CCN: 132846

CONTRACT NO. DE-AC27-01RV14136 – REPORT OF EXTERNAL FLOWSHEET REVIEW TEAM FOR THE HANFORD TANK WASTE TREATMENT AND IMMOBILIZATION PLANT - FINAL REPORT TITLED: "COMPREHENSIVE REVIEW OF THE HANFORD WASTE TREATMENT PLANT FLOWSHEET AND THROUGHPUT"

Comprehensive Review of the Hanford Waste Treatment Plant Flowsheet and Throughput

**Assessment Conducted by an Independent
Team of External Experts**

Figure 2. Expected WTP Feed Variability [data taken from V. Vora, *Dynamic (G2) Model Version 3.1 Verification and Validation Report*. 24590-WTP-VV-PO-04-0004, Rev. 0., September 2, 2004]. Circles represent the predicted composition for each WTP feed batch.

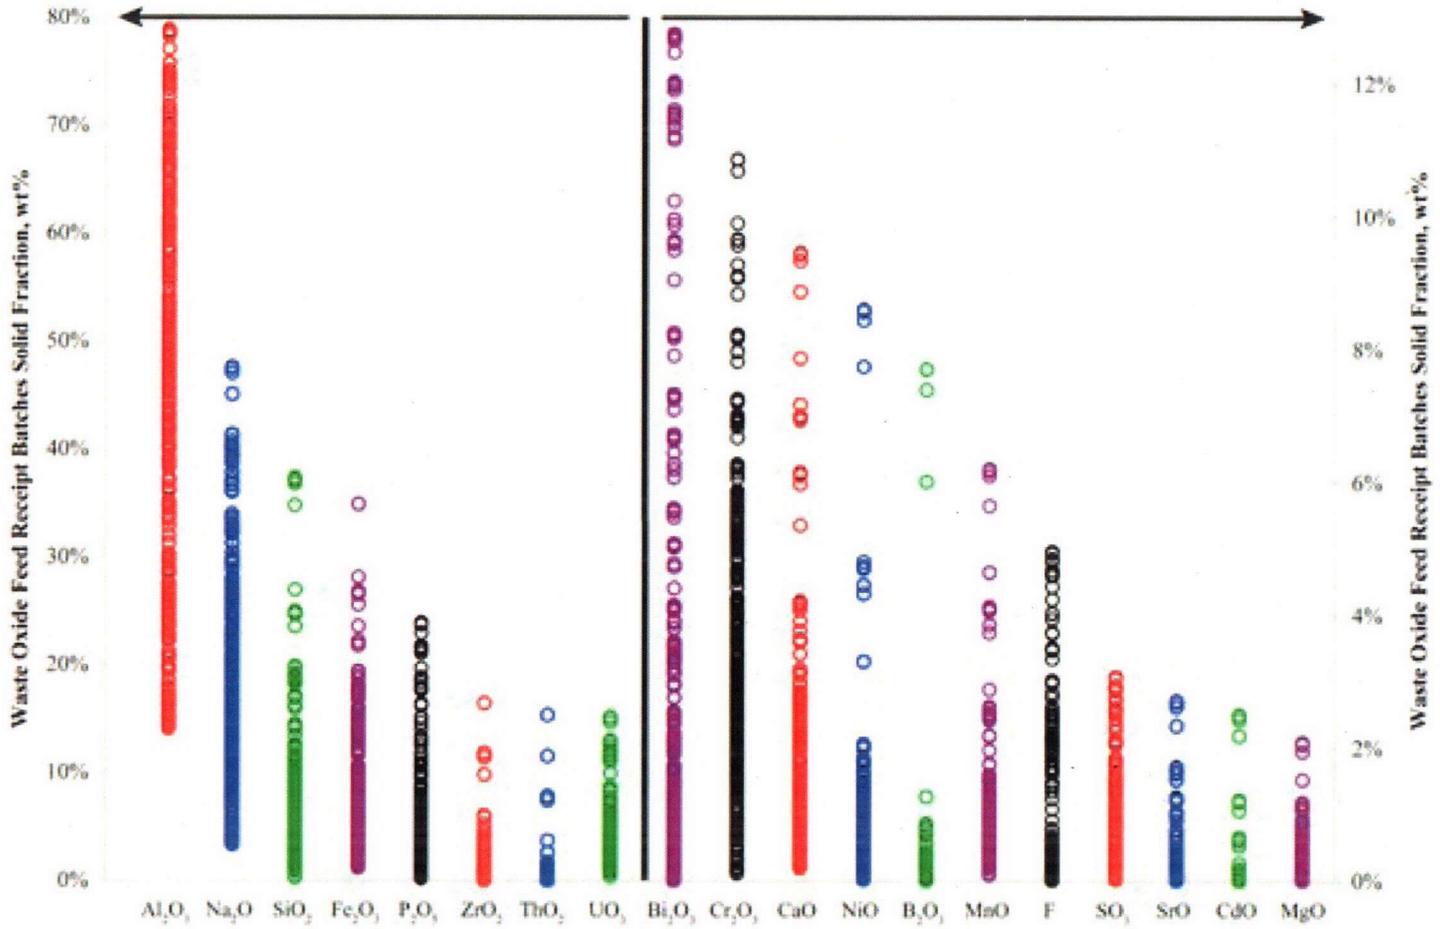
The range of waste compositions (expressed as oxides) currently anticipated to be received by the WTP is shown in Figure 2. Species important to glass performance or processing vary greatly. For example, the aluminum content varies by a factor of 7; the sodium content by a factor of 16. This variability affects equipment design; Plant operations; glass formulations; and, if not designed for, subsequently Plant throughput.

The process flowsheet and Plant design should take the wide range of feed compositions into account. The insoluble waste feed to the WTP will have large fluctuations in the concentrations of iron, aluminum, strontium, sodium, zirconium, and other waste constituents. While the fluctuations for the soluble wastes will be less pronounced, they will also be significant. As a result, the HLW material delivered to the WTP from the tank farms will vary considerably from batch to batch, where “batch” in this context means an approximate 1-million-gallon quantity of waste staged at the tank farms ready to transfer to the WTP.

The WTP must consider the impacts of the feed variability on the Plant’s ability to support the removal of waste from the Hanford tank farms. Even with the feed pre-qualification step recommended by the EFRT, adaptation of glass product control models to include new waste compositions could significantly delay processing. Plugging due to phosphates in soluble wastes has caused serious consequences in the Hanford tank farms and must be addressed before radioactive operations are initiated. An experimental program to resolve

Figure 4. Correlations of UFP Filter Solids Concentration and Permeate Flux Data for WTP (taken from D. Alexander et al., *Design Oversight Report, HLW Feed Preparation System; Ultra-Filtration Process System*, Figure A.1, D-03-DESIGN-005, DOE ORP, April 2004; BNI CCN 094035, June 6, 2004)

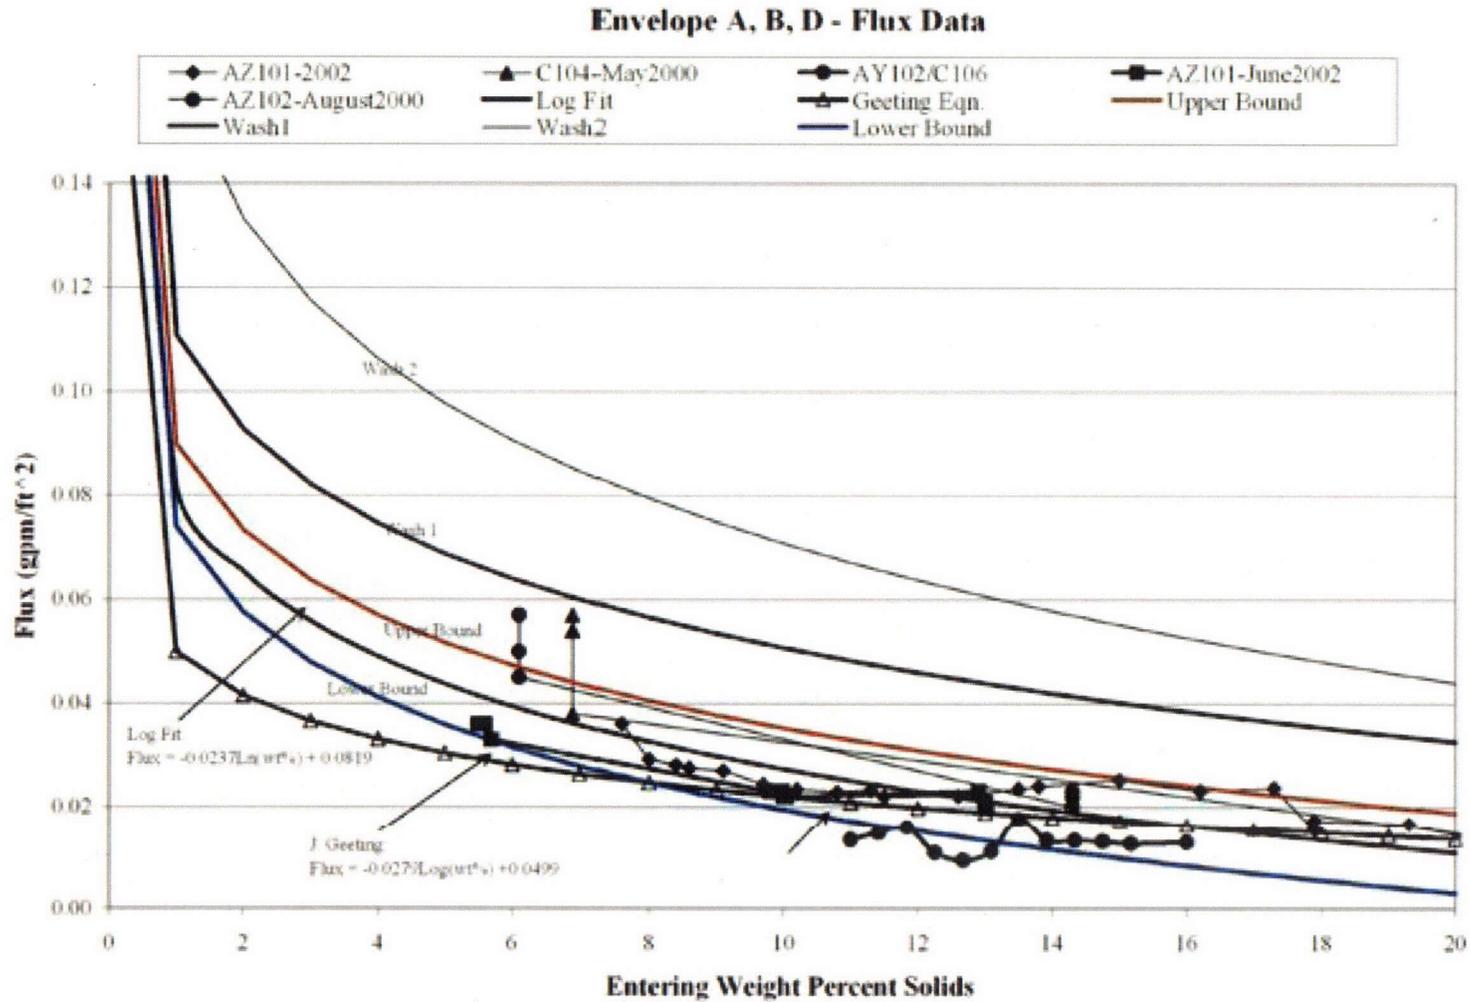
These calculations show that either increasing the filter area by a factor of two or achieving the design flux raises the 100% process capacity to levels that would support the production of 80 MT/day of LAW glass. The actual flux will be known only after the process is operating. It is the EFRT's expectation, based on the data shown in the curve in Figure 4, that the flux will be 0.015 gpm/ft².
